Subject: Sequoyah Fuels Corporation, Docket – 40-8027
Response to Request For Additional Information – Reclamation
Plan – Ground Water Protection (TAC L52511)

Enclosure 1
Sequoyah Fuels Corporation
Response to Request for Additional Information
Reclamation Plan Review
Ground Water Protection

GW3 Detection Monitoring

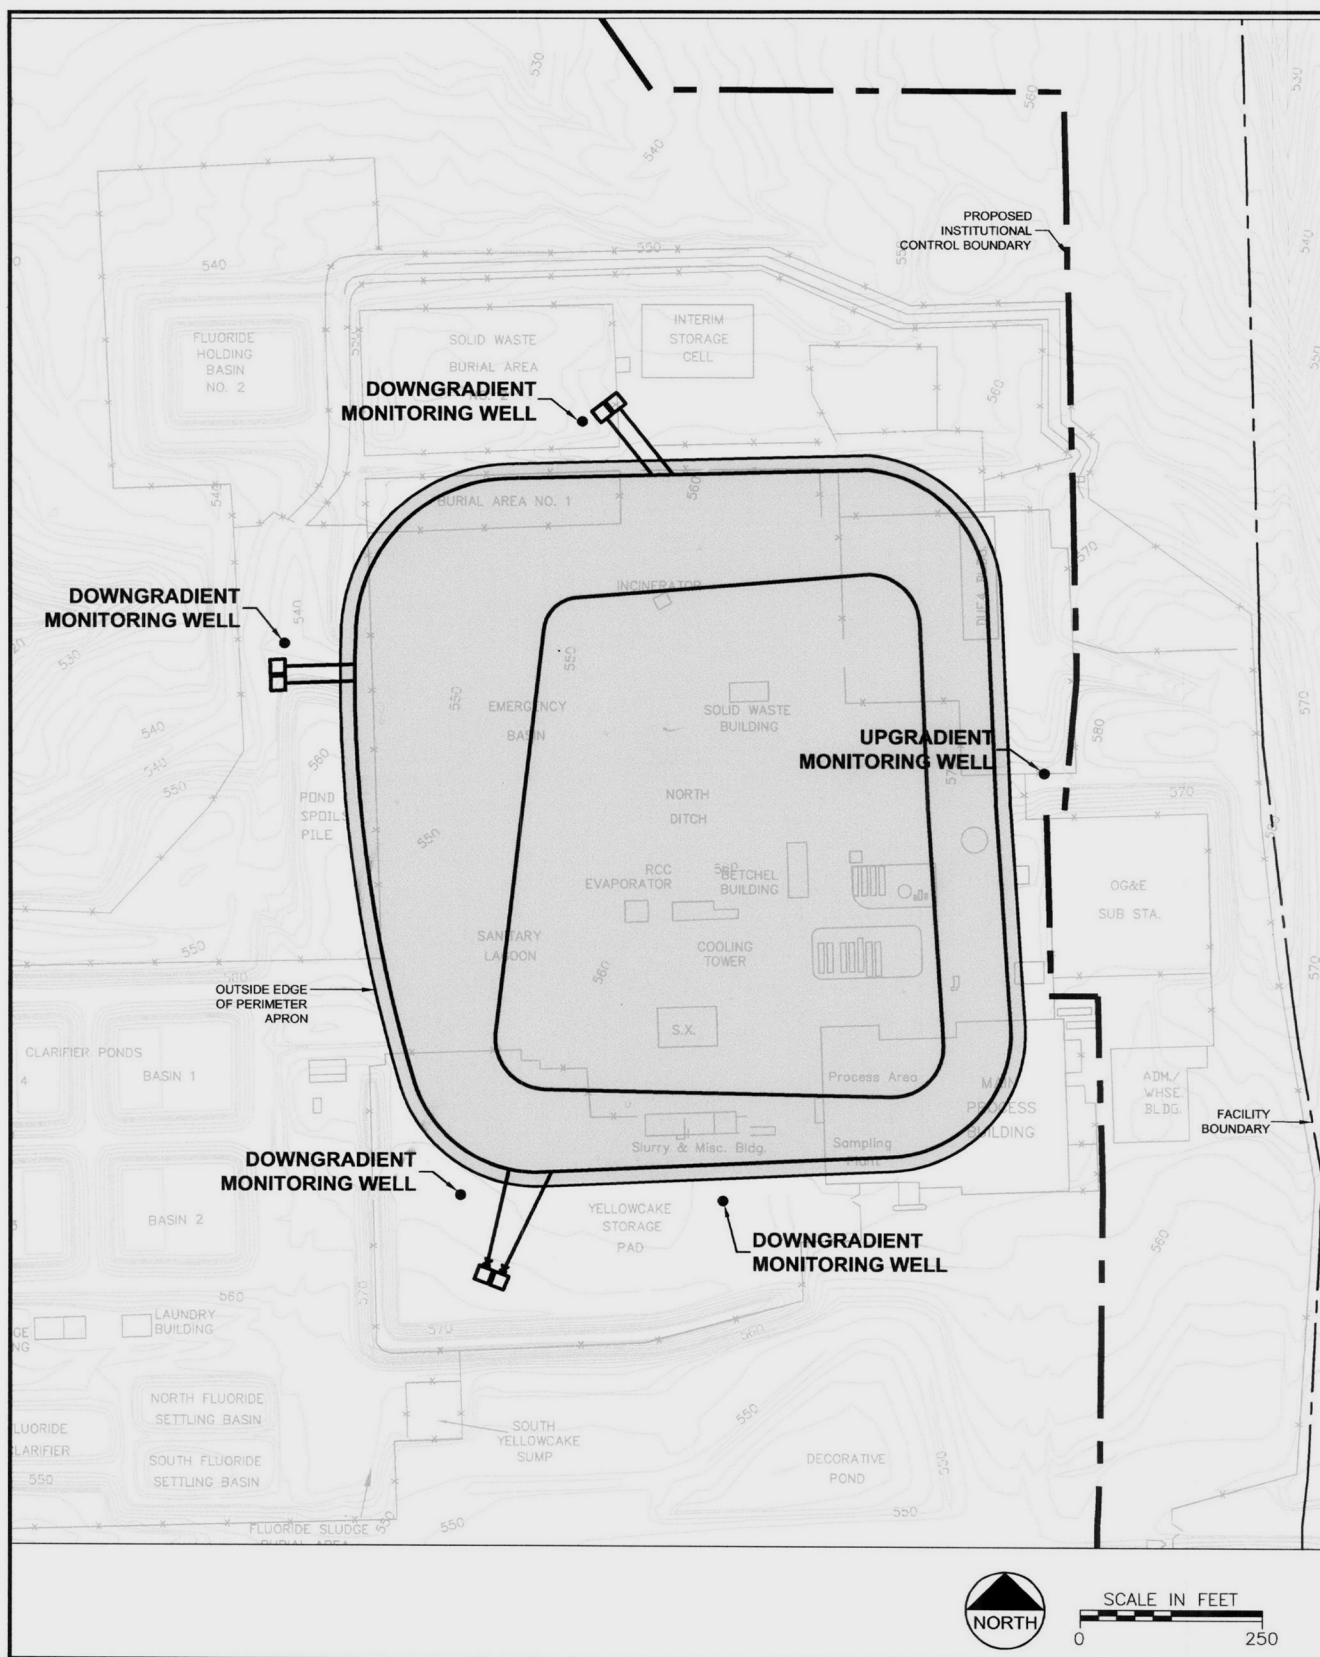
- A** **REQUEST:** A discrepancy exists between the written geologic descriptions and associated maps contained in Appendix D. Page 3-14 states that Sandstone 1 underlies the Terrace Groundwater System; however, cross-sections contained in Figure 11, Appendix D, and in Figure 14 of the Reclamation Plan show that Shale 1 underlies the Terrace system. Please clarify this discrepancy.

There have been numerous conceptual groundwater models used at the site over the last 15 to 20 years. Each of these site models have referred to the geologic conditions in a slightly different manner. The use of similar terminology to represent slightly different geologic layers has caused some confusion. The current site model is the most comprehensive and has divided the groundwater system into the discrete geologic units that exist at the site. That conceptual model is described in the Hydrogeological and Geochemical Site Characterization Report (HGSCR) (Appendix B of the Reclamation Plan).

The term Terrace Groundwater System, as discussed in the request above, refers to the uppermost interconnected aquifer system that is comprised of the upper terrace soils and Shale 1. The Terrace Groundwater System is perched on top of Sandstone 1.

FIGURE 1
CELL MONITORING WELLS

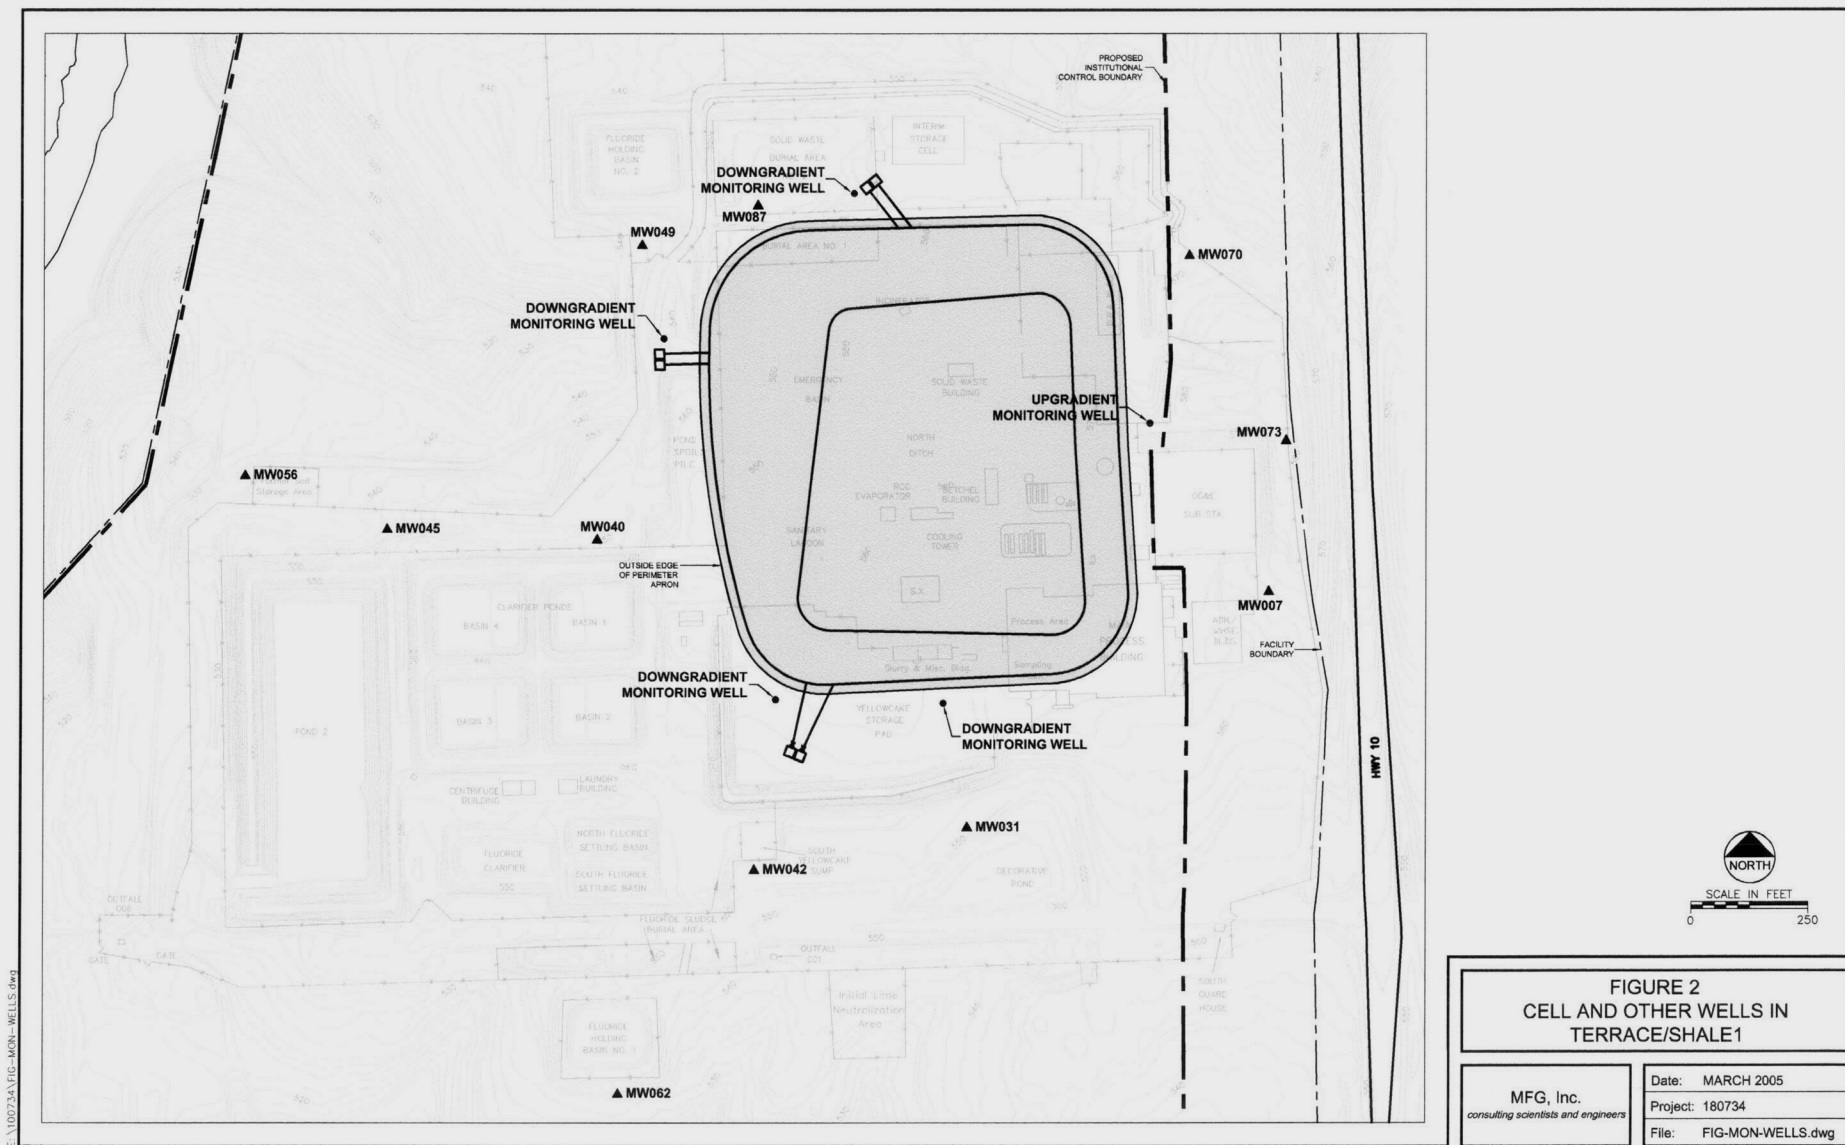
- B** **REQUEST:** Section 7.0, Attachment E of the Reclamation Plan indicates that three point of compliance (POC) wells are proposed for the disposal cell monitoring network. Such a network assumes that ground water gradients will remain largely unaffected by the presence of an above ground disposal cell. However, topographic alterations, such as

disposal cells, can cause localized changes in groundwater gradients because of the higher total hydraulic head in the disposal cover. Such conditions could cause ground water to migrate radially away from the disposal cell for a certain distance before being overcome by the regional groundwater gradient. Therefore, SFC should propose additional POC wells along the disposal cell circumference or provide justification that the three proposed wells will provide sufficient coverage after the disposal cell is built.

There are five proposed wells to monitor groundwater from the cell. The location of these wells is illustrated on Figure 1 and shown on the design drawings for the cell. The wells have been located based on the site specific geohydrologic conditions. Specifically, one well is located east of the cell which is up-gradient, while the other four wells are located west, north-west, south-west and south of the cell. These four directions are down-gradient from the cell.

Given the nature of the cell and the local hydrologic conditions, the five proposed wells, in conjunction with the monitoring program detailed above, will be sufficient to provide leak detection monitoring.
